SERVICE BULLETIN

No.**292 72 2087**

ARRIEL 2 B - B1 - C - C1 - C-PM - S1

Subject: M03 module (gas generator). Protection of the HP turbine blades with electrolytic NiCoCrAlYTa.**Application of modification TU 87A.**

Figure 1

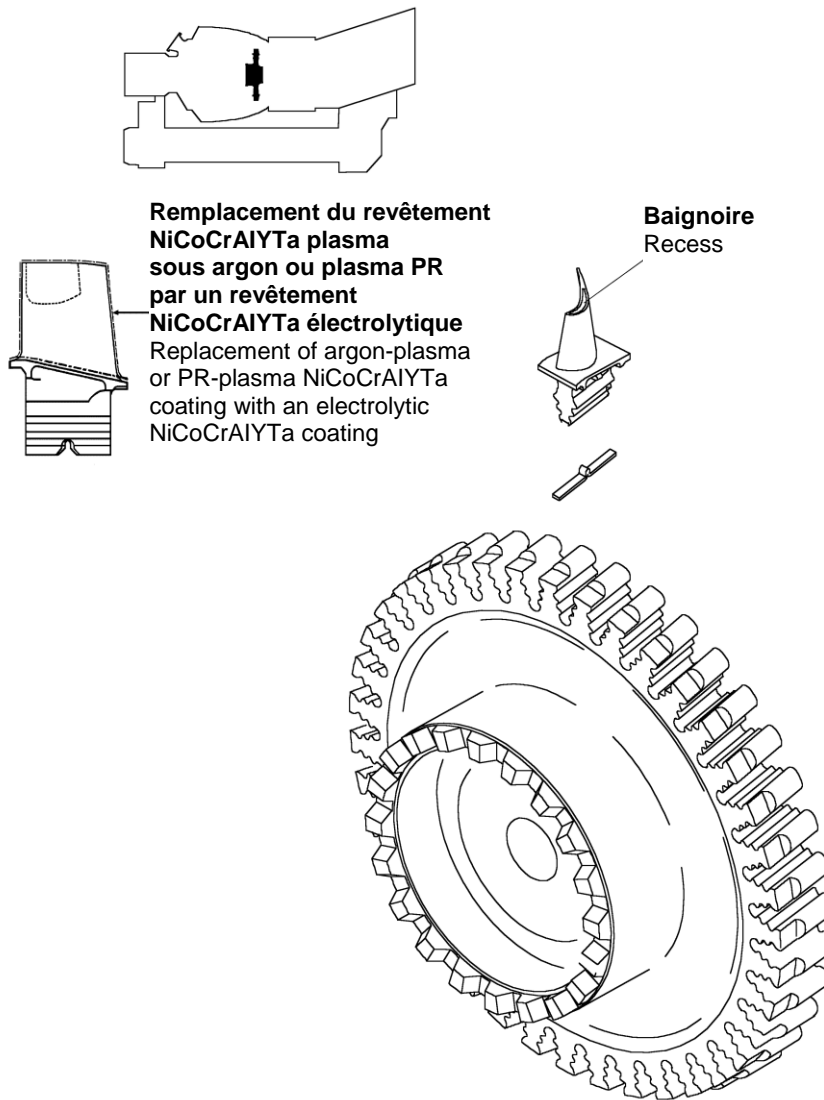
C. Description (Appendix 1 - Figure 1)

This modification consists in replacing the argon-plasma or PR-plasma NiCoCrAlYTa coating on the HP blades with an electrolytic NiCoCrAlYTa coating.
